Technical Bulletin

Technical Bulletin Unique Identifier	DOC2884628
Title	Service Note for content update in Section 7.2.11 of MR450w non-GEM to SIGNA Artist Upgrade Manual
Subject	Content update in Section 7.2.11 of MR450w non-GEM to SIGNA Artist Upgrade Manual
Applicability (e.g., affected product, process)	MR Optima MR450W 1.5T MR Signa Artist 1.5T
Date	29-Aug-2023
Relevant Product Business (select one)	☒ Imaging ☐ Patient Care Solutions ☐ Ultrasound ☐ Other: _____
Originating Modality	MR
Details	Service Note for content update in Section 7.2.11 of MR450w non-GEM to SIGNA Artist Upgrade Manual
Tracking Number	N/A
Affected Service Publications	MR450w non-GEM to SIGNA Artist Upgrade Manual Part #: 5791841 Rev.8 Class A
Resolution	See attached
Technical Bulletin Owner	Qin Yu (SSO: 503343456)

7.2.11 Install Middle Support Bracket (Dv Magnet)

Figure 1 (Figure 123 in manual). Middle Supports

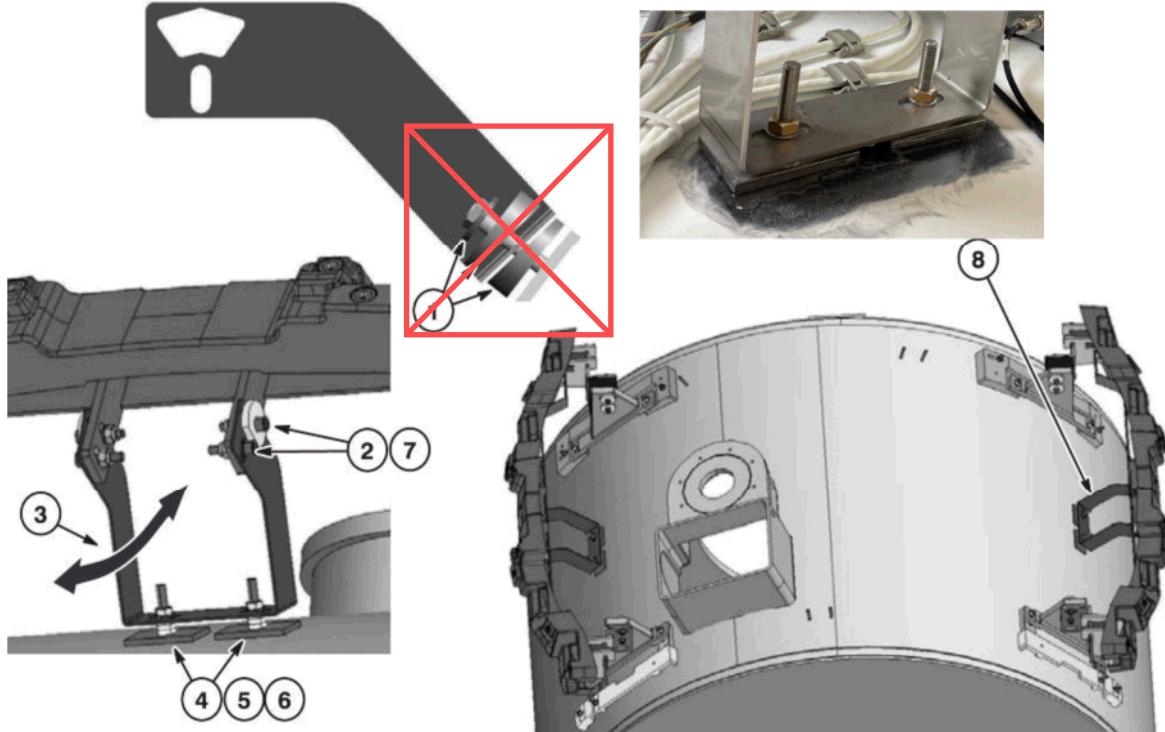
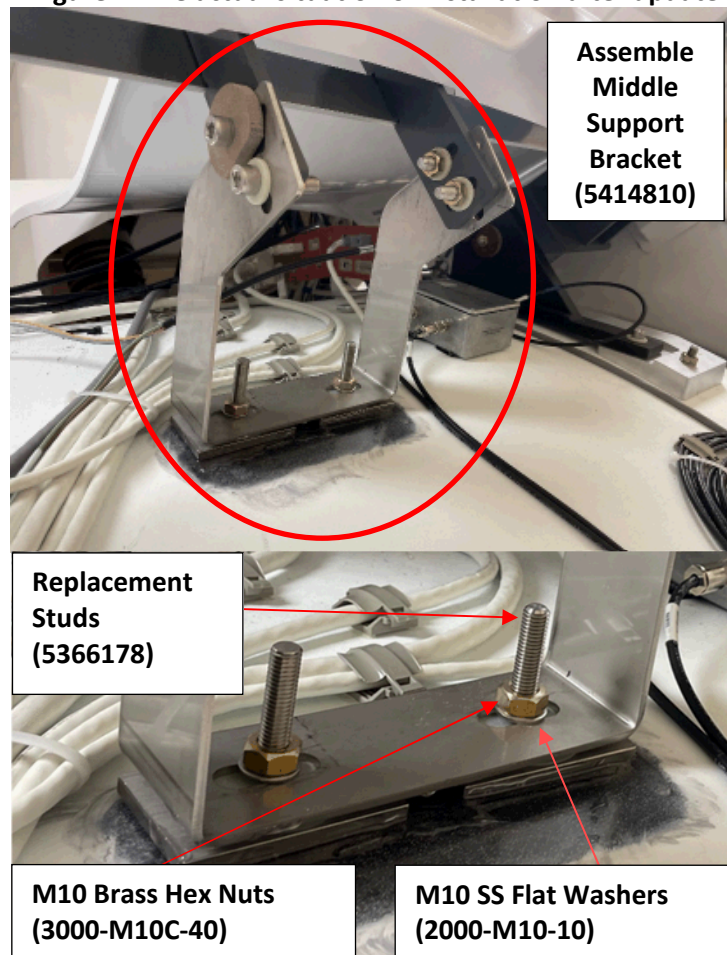
Since it was found from the site that four **(4) M10 Wedge Spacer Washers (5417957)** described in Step 1 of **Chapter 7.2.11 Install Middle Support Bracket (Dv Magnet)** does not exist in the BOM and was not found in the site, to avoid misunderstandings.

This SN updates step 1 of the MR450w to Signa Artist upgrade manual. Replace the content of the original **red text** of Step1 with the content of the following **green text**.

1. Assemble Middle Support Bracket (5414810), and Replacement Studs with two (2) M10 Brass Hex Nuts (3000-M10C-40), two M10 SS Flat Washers (2000-M10-10), and four (4) M10 Wedge Spacer Washers (5417957).

NOTE: Make sure the M10 Wedge Spacer Washers are aligned as shown above.

Figure 2. The actual situation of installation after update

1. Assemble Middle Support Bracket (5414810), and Replacement Studs (5366178) with two (2) M10 Brass Hex Nuts (3000-M10C-40), two (2) M10 SS Flat Washers (2000-M10-10).
